Access Compliance Report Public Rights-of-Way (Curb Ramps)

Intersection ID: 49346Main Street:BLUE_JUNCTION_RDCross Street:FIRESPIKE_RDLocation:SEADA ID: 88C1625E37B7Ramp Type:PerpInitial Pass/Fail:FailOverall Compliance:NoSeverity Score:10

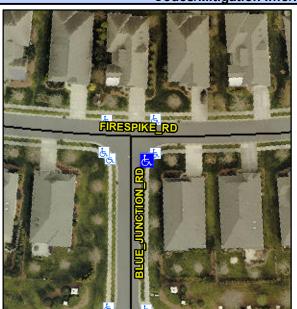
Not Found, R304.5.1, R304.5.3

rieid Measurements/Component Compilance					
Compliance Description		Data	Compliance Description		Data
N/A	Ramp Length (in)	48.0	Yes	Ramp Slope (%)	5.1
No	Ramp Width (in)	47.0	No	Ramp XSlope (%)	3.2
N/A	Flare Type LT	N/A	N/A	Flare Type RT	N/A
N/A	Flare Slope LT (%)	N/A	N/A	Flare Slope RT (%)	N/A
N/A	Flare Traversable LT?	N/A	N/A	Flare Traversable RT?	N/A
N/A	Landing Length (in)	N/A	N/A	DWS Provided?	N/A
N/A	Landing Width (in)	N/A	N/A	DWS Contrast?	N/A
N/A	Landing Slope (%)	N/A	N/A	DWS Length (in)	N/A
N/A	Landing X Slope (%)	N/A	N/A	DWS Full Width?	N/A
N/A	Landing Curb? (Y/N)	N/A	N/A	DWS Offset (in)	N/A
N/A	Shared Landing?	N/A			
N/A	Gutter Ponding?	N/A	N/A	Gutter Slope (%)	N/A
N/A	Gutter Lip Ht (in)	N/A	N/A	Gutter X Slope (%)	N/A
N/A	Painted X Walk1?	No	N/A	Painted X Walk2?	N/A
	X Walk 1 Direction	To NW		X Walk 2 Direction	N/A
N/A	X Walk 1 Width (in)	N/A	N/A	X Walk 2 Width (in)	N/A
	X Walk 1 Slope (%)	1.3		X Walk 2 Slope (%)	N/A

Remove & Replace Entire Ramp.
